**STOREFRONT
MODIFICATIONS
TO**

150 WORTH AVENUE UNIT 225
PALM BEACH
FLORIDA 33480

RFI 136

UNIT 219 AND 225

2 PROPOSED STOREFRONT FLOOR PLAN
Scale: 3/16" = 1'-0"

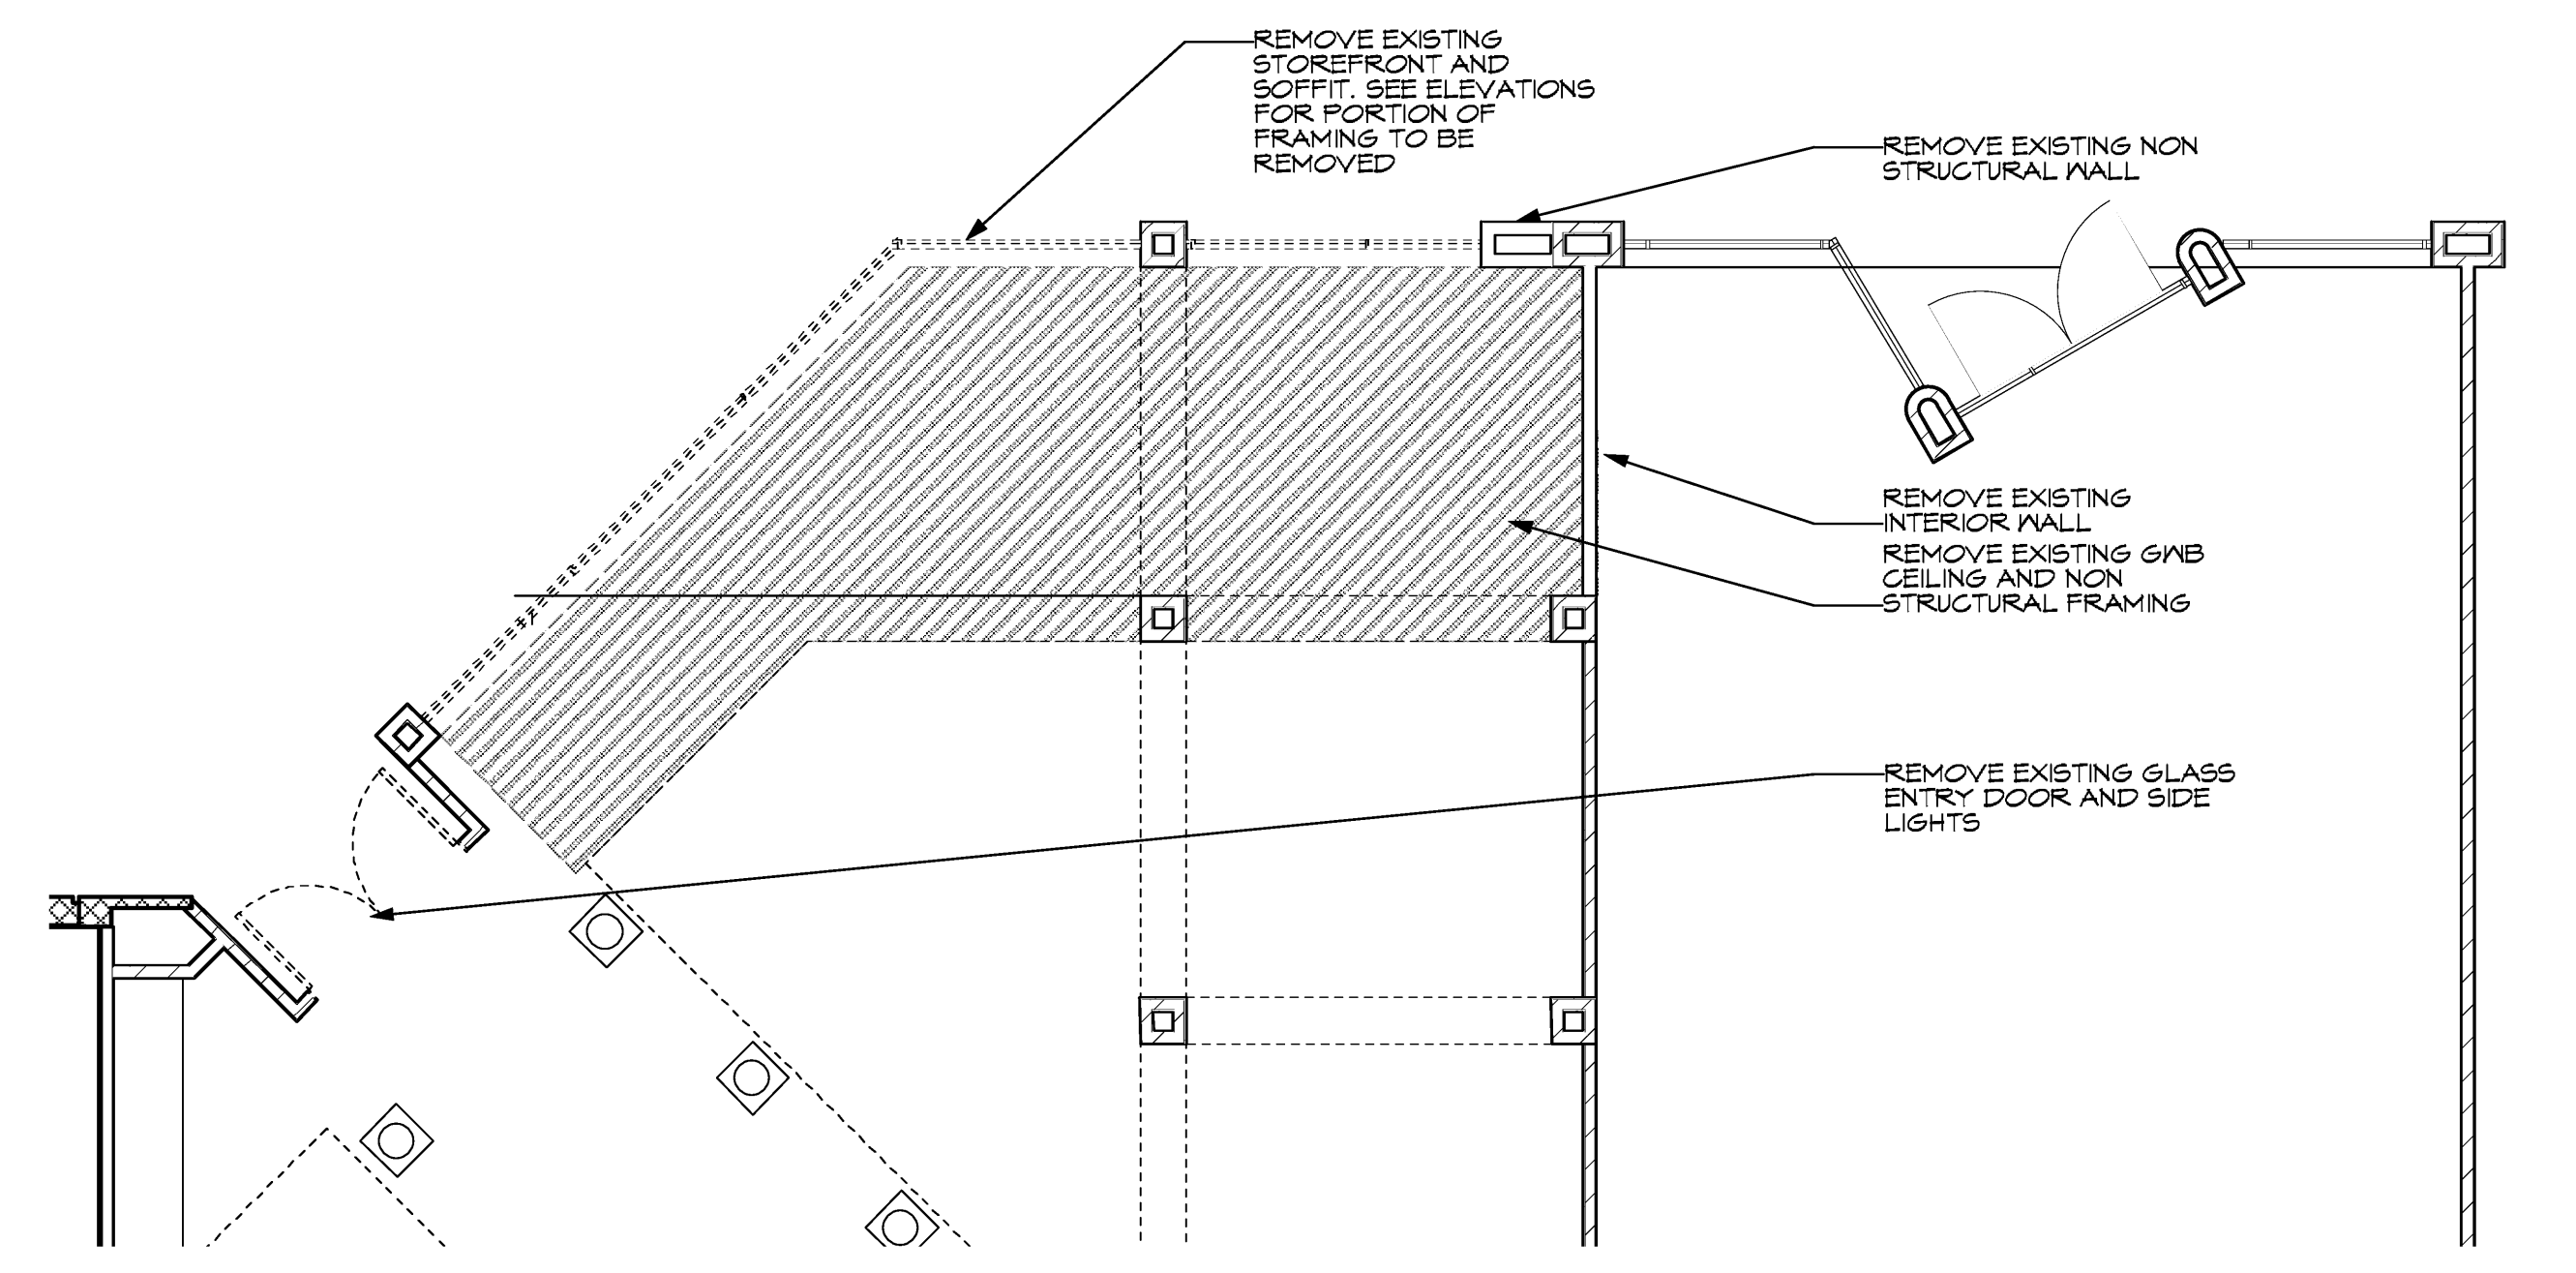
There is no demolition plan associated with the removal of the storefront system and associated components. Will any shoring be required prior to the removal of the existing storefront assembly? **SEE DEMO PLAN SHEET A1**

3 SECTION THRU STOREFRONT
Scale: 3/4" = 1'-0"

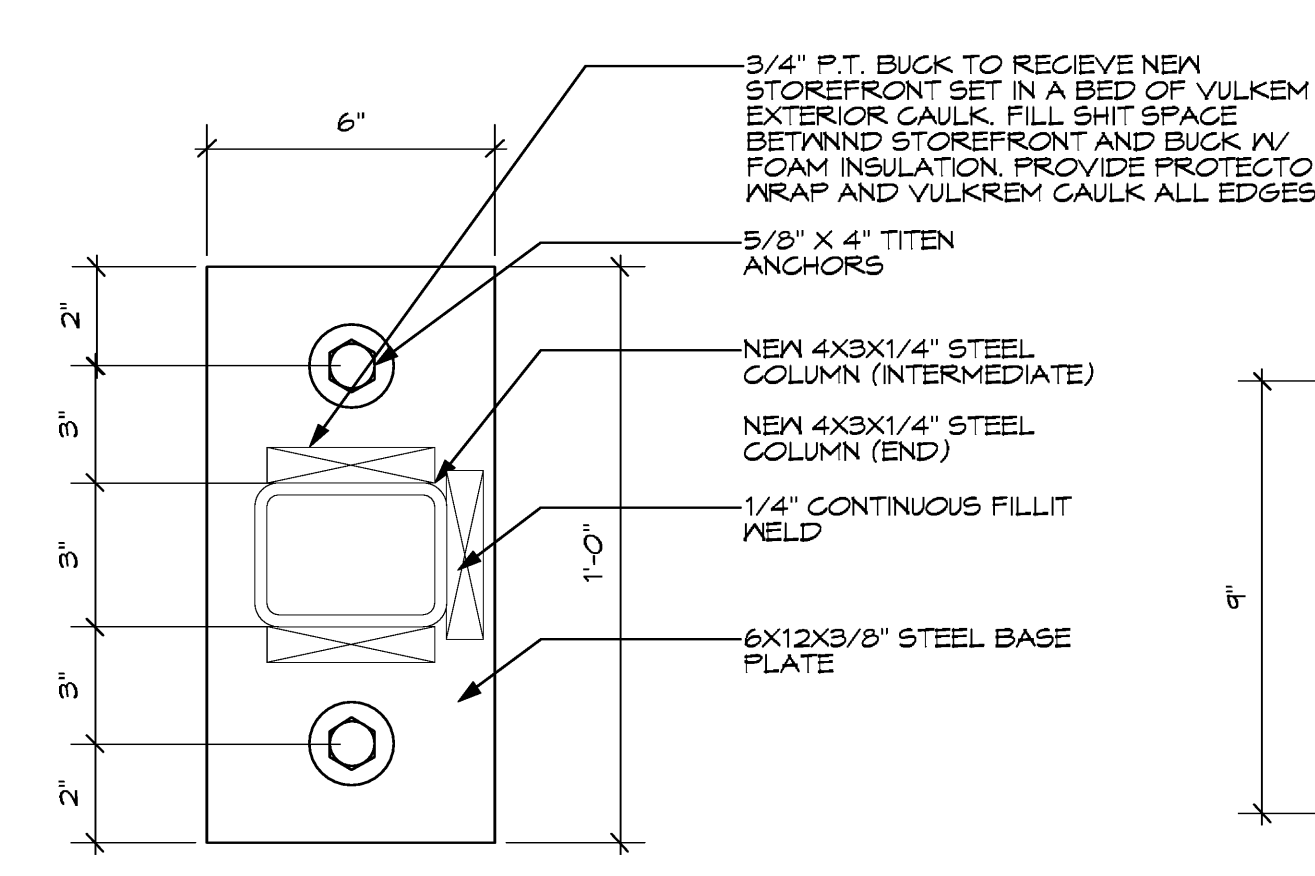
13. Note 3-S1 indicates an additional 4x4x1/2 steel column not shown elsewhere on the plan. Please clarify this detail. **PLEASE CLARIFY QUESTION**
14. There are no light fixture models/catalog numbers listed. **SEE ELECTRICAL PLAN**

4 COLUMN PLATE DETAIL TOP AND BOTTOM
Scale: 3" = 1'-0"

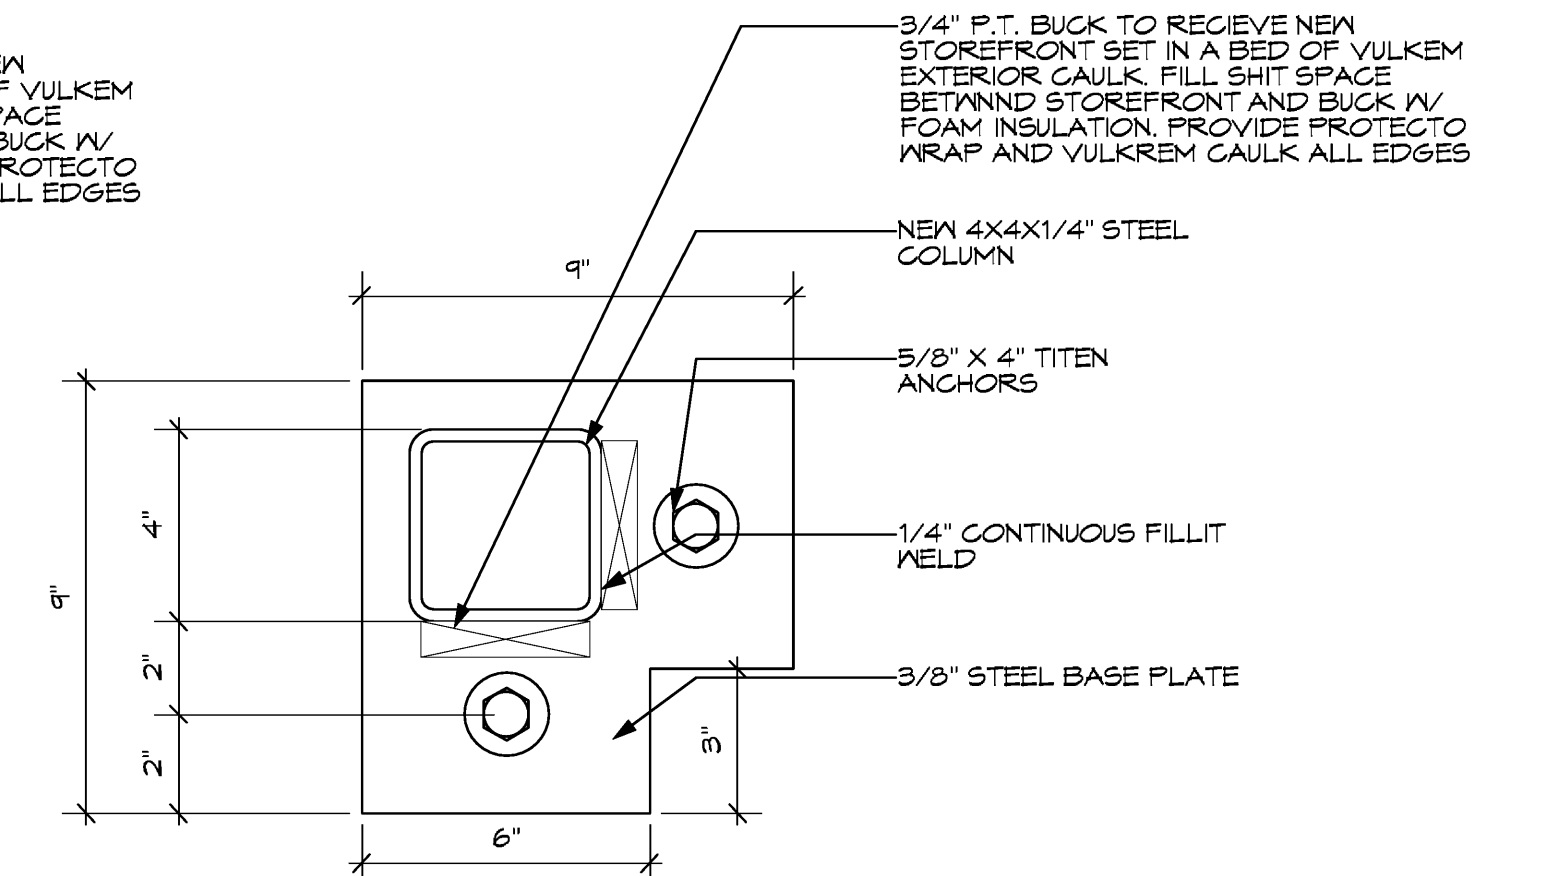
11. The walls shown with the pocket doors are shown as new but are not shown as being demo'ed. Are **these** new walls? **SEE REVISED PLAN**
12. The note 4-S1 should be corrected before permitting. **NOTED**

MECHANICAL FLOOR PLAN
SCALE: 1/4"=1'-0"

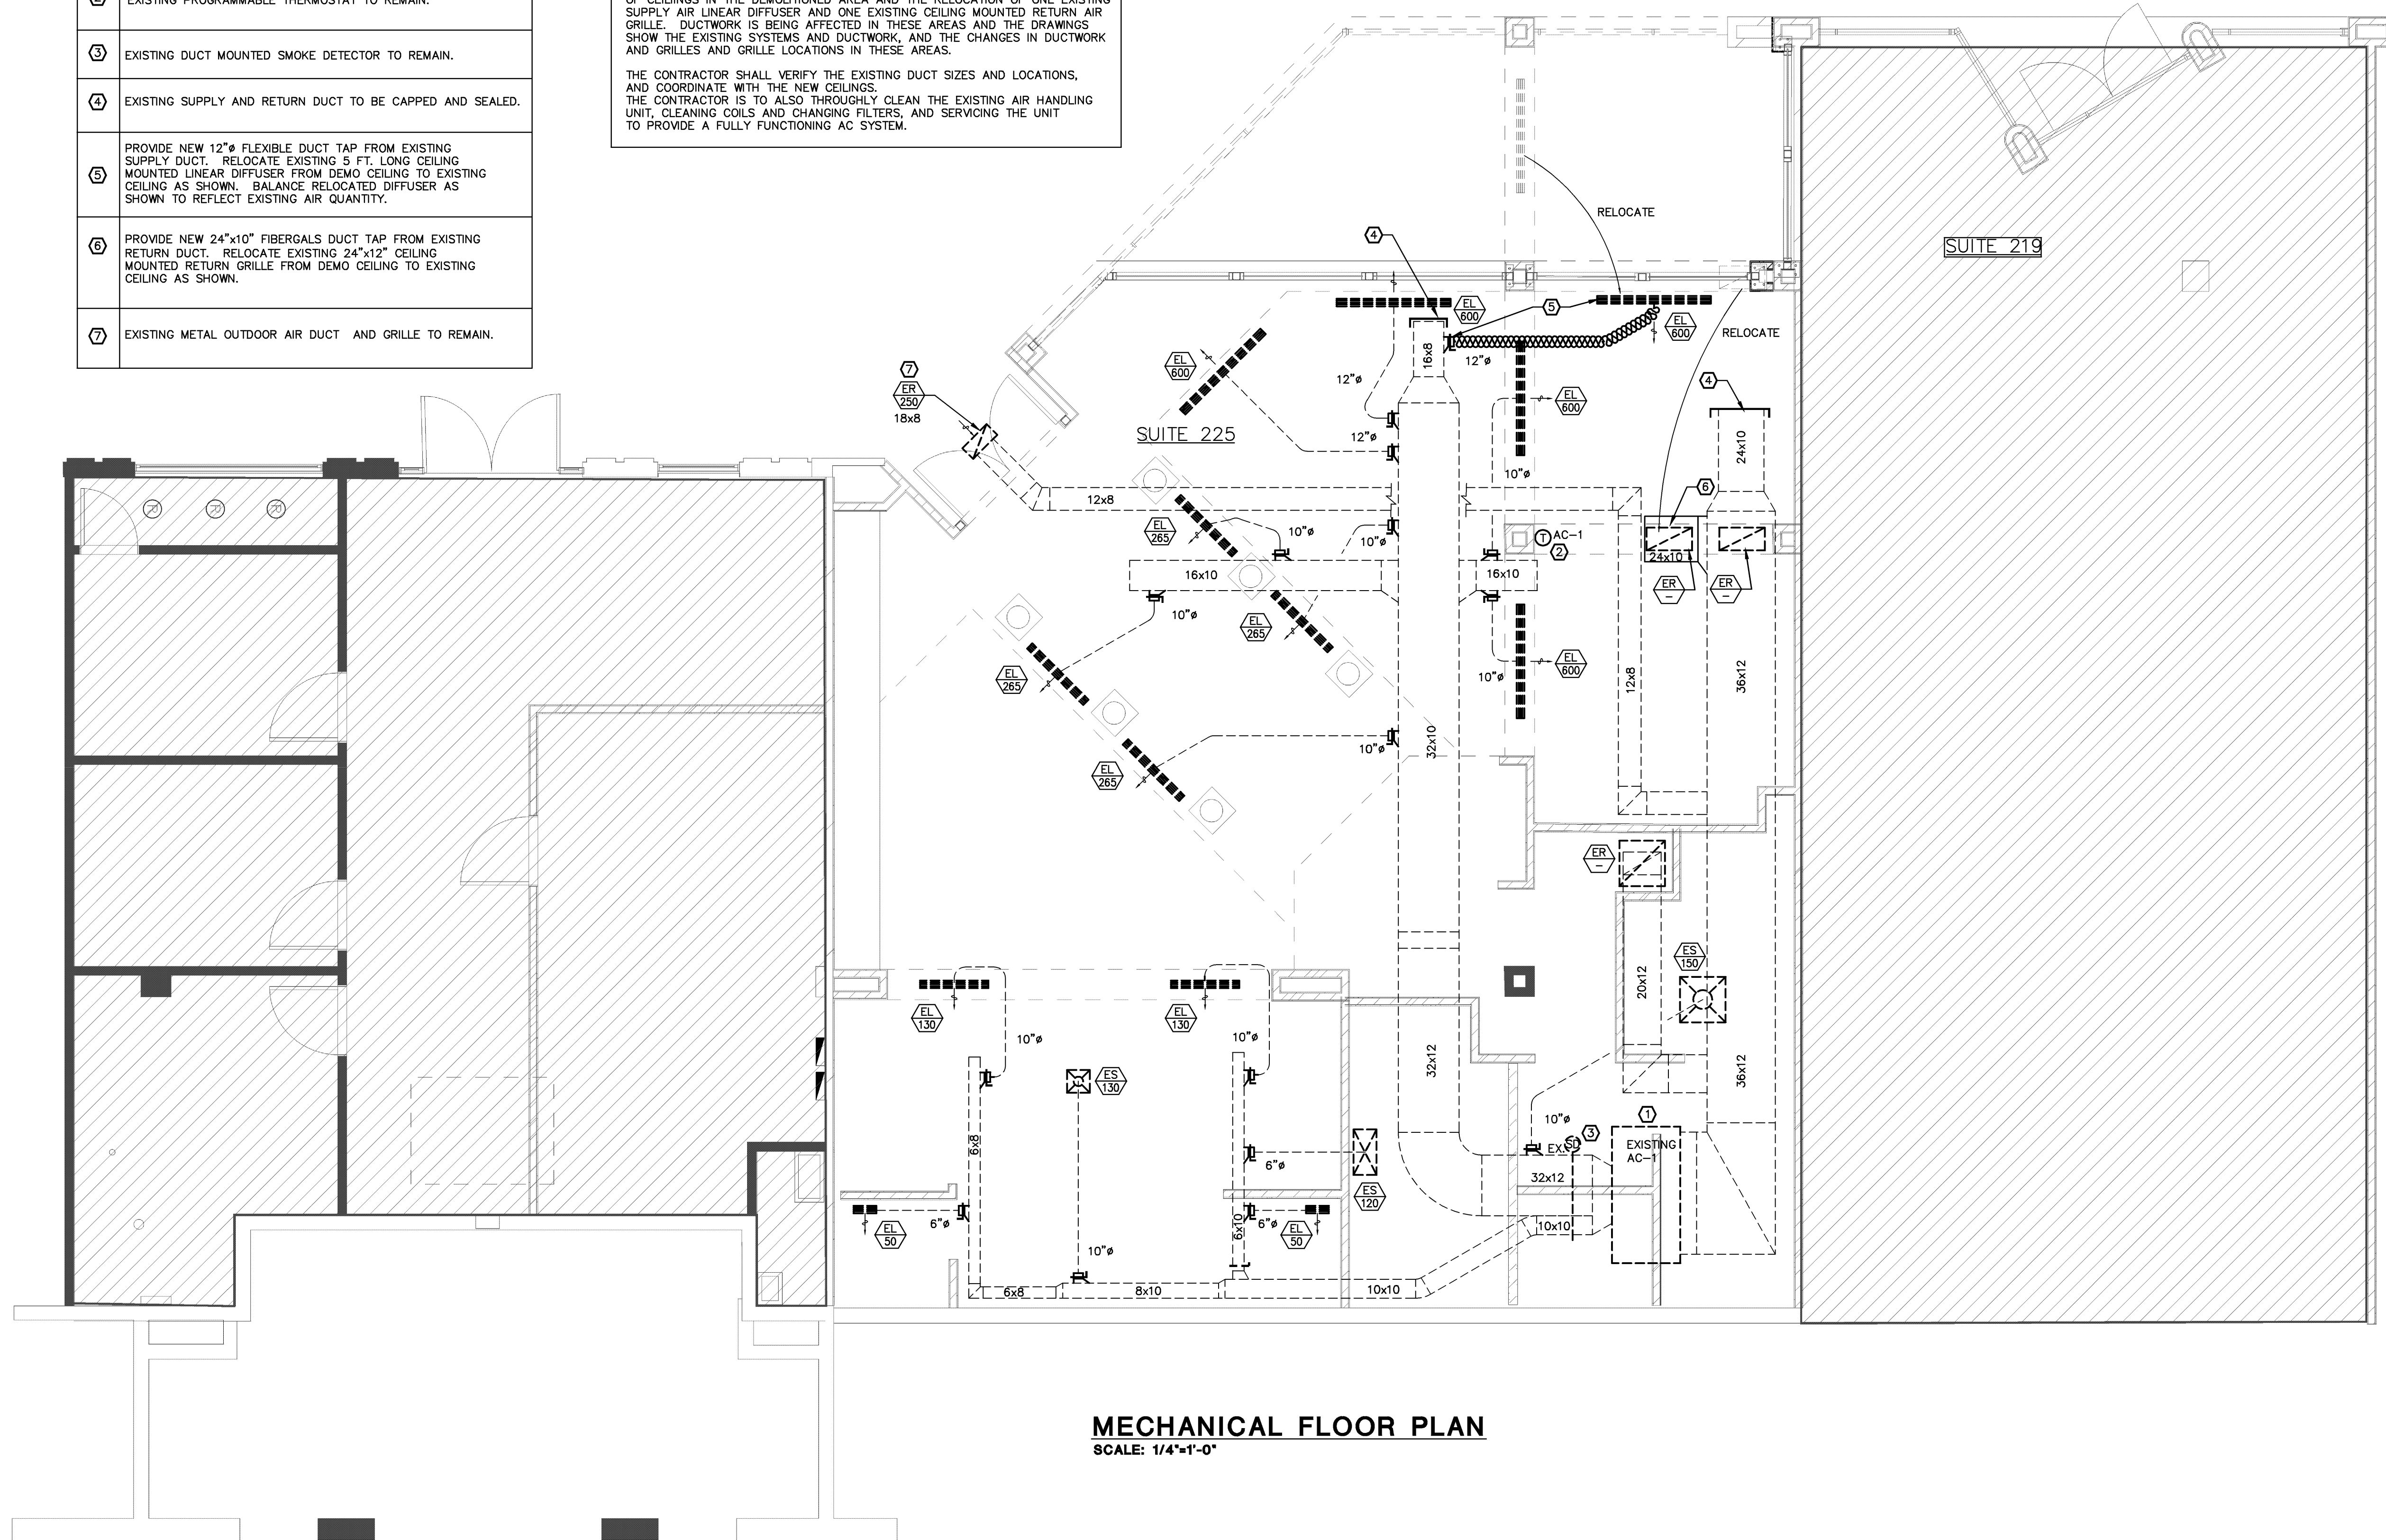
Sheet m1, key plan notes #5 & #6 refer to demoed ceiling, however no demoed plans are included. **SEE ARCHITECTURAL**
